Planning Commission Staff Report

Project Type:	Amended Sign Package
Meeting Date:	November 9, 2020
From:	Chris Dietz, Planner
Location:	6 McBride and Son Center Dr.
Description:	<u>McBride & Son Center, Lot 3 (Medical Building) Sign Package:</u> A request to amend a sign package for a medial office building on a 1.69-acre tract of land located southwest of the intersection of Boone’s Crossing and Interstate 64 (17U610106).

Figure 2: North Elevation

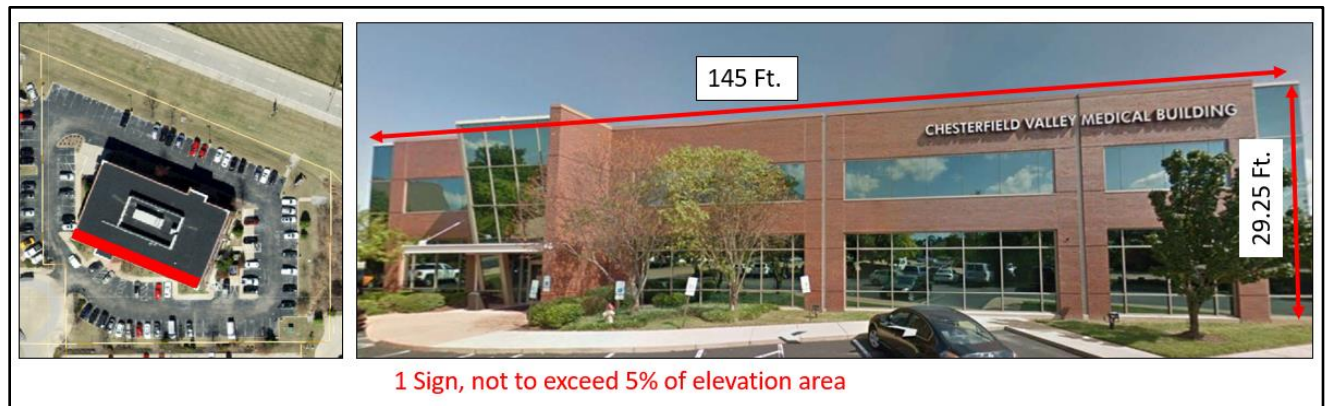
The proposed amended sign package would allow one (1) wall sign on each of the south, east and west building façade and two (2) signs anywhere on the north façade facing I-64, with a total signage area not to exceed 5% of each elevation’s façade area.

Figure 6: Freestanding Signs

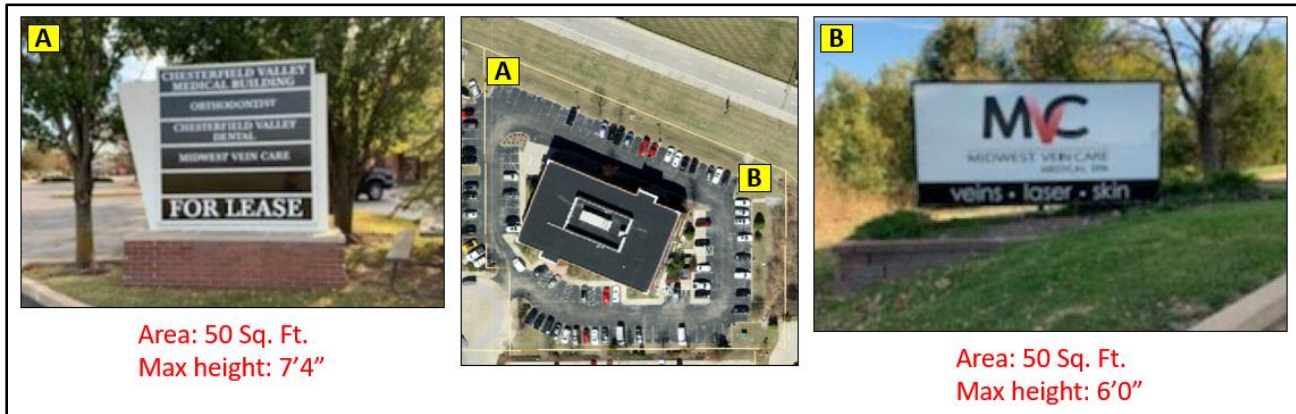
The site currently has two (2) freestanding signs, located in the northwest corner of the lot along I-64, and the other located in the northeast corner, along Boone’s Crossing. These signs’ dimensions would be incorporated into the proposed sign package criteria. The location of any freestanding signage would need to comply with the location shown on the approved Site Development Section Plan. In addition, the UDC states that all freestanding signage must be adequately landscaped. The sign along I-64 currently lacks landscaping, and the applicant has stated in the project narrative that this issue will be resolved.
